CONTRACT NO. DE-AC27-01RV14136 – TRANSMITTAL OF THE U.S. DEPARTMENT OF ENERGY, OFFICE OF RIVER PROTECTION (ORP) DESIGN ASSESSMENT REPORT NUMBER D-07-DESIGN-039: REVIEW BECHTEL NATIONAL, INC. (BNI) GLASS FORMER FACILITY (GFF) SUPPORTING THE PROPOSED LOW-ACTIVITY WASTE (LAW) AND HIGH-LEVEL WASTE (HLW) DESIGN CAPACITIES

**Review  
Bechtel National, Inc.  
Glass Former Facility (GFF)  
Supporting Increased  
Low-Activity Waste (LAW) and High-Level Waste (HLW) Design Capacities**

**Design Assessment Report: D-07-Design-039**

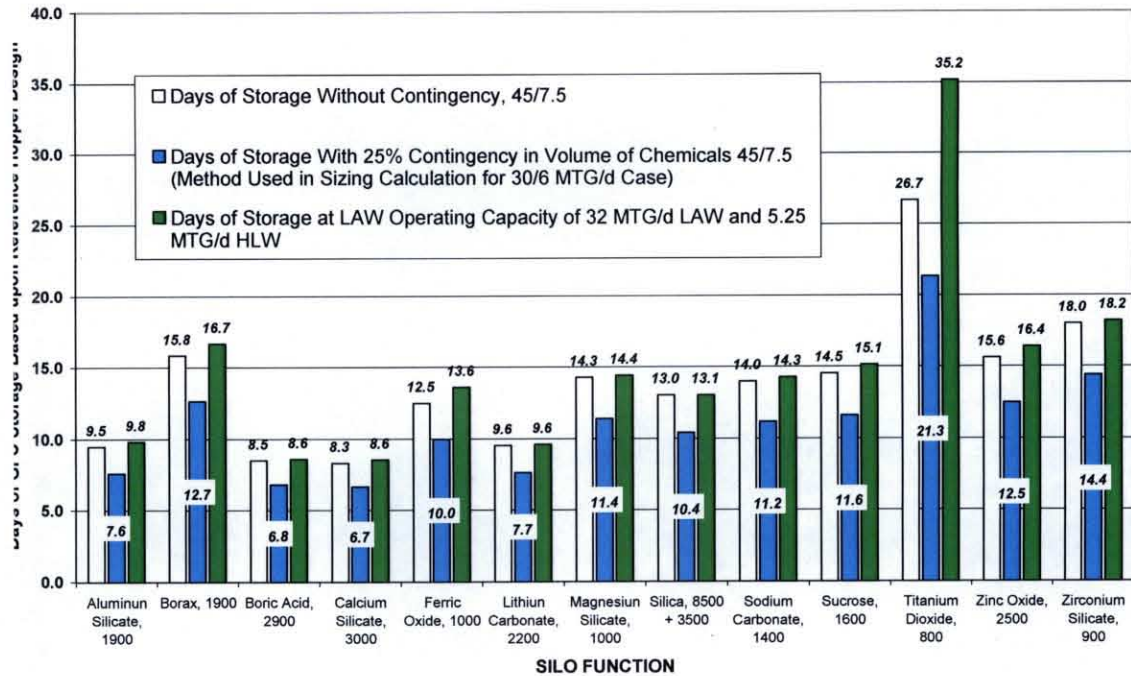
- d. Each GFC calculation in the graph below uses the sequence shown in Section 4.2. The graph below depicts the usage of each GFC for the LAW and HLW Facilities for the following scenarios:
1. Days of GFC storage without contingency for proposed increased throughput capacities (white);
  2. Days of GFC storage with 25% contingency for proposed increased throughput capacities (blue); and
  3. Days of GFC storage for the proposed increased LAW and HLW throughput capacities at 70% operating capacity (green).

- Although silica is the most used chemical in both LAW and HLW, GFCs such as boric acid and calcium silicate have less storage capacity due to silo size, as shown in the graph above. By increasing the throughput capacities for LAW and HLW, the amount of storage days per GFC silo decreases. However, this can be mitigated by increasing scheduled GFC deliveries. Currently all GFC silos have been sized for a 10-day supply or a 5-day supply plus truckload, whichever is greater (a truckload equals 48,000 lb). The current silo storage sizes are based on a LAW production rate of 30 MTG/day and HLW production rate of 6 MTG/day.
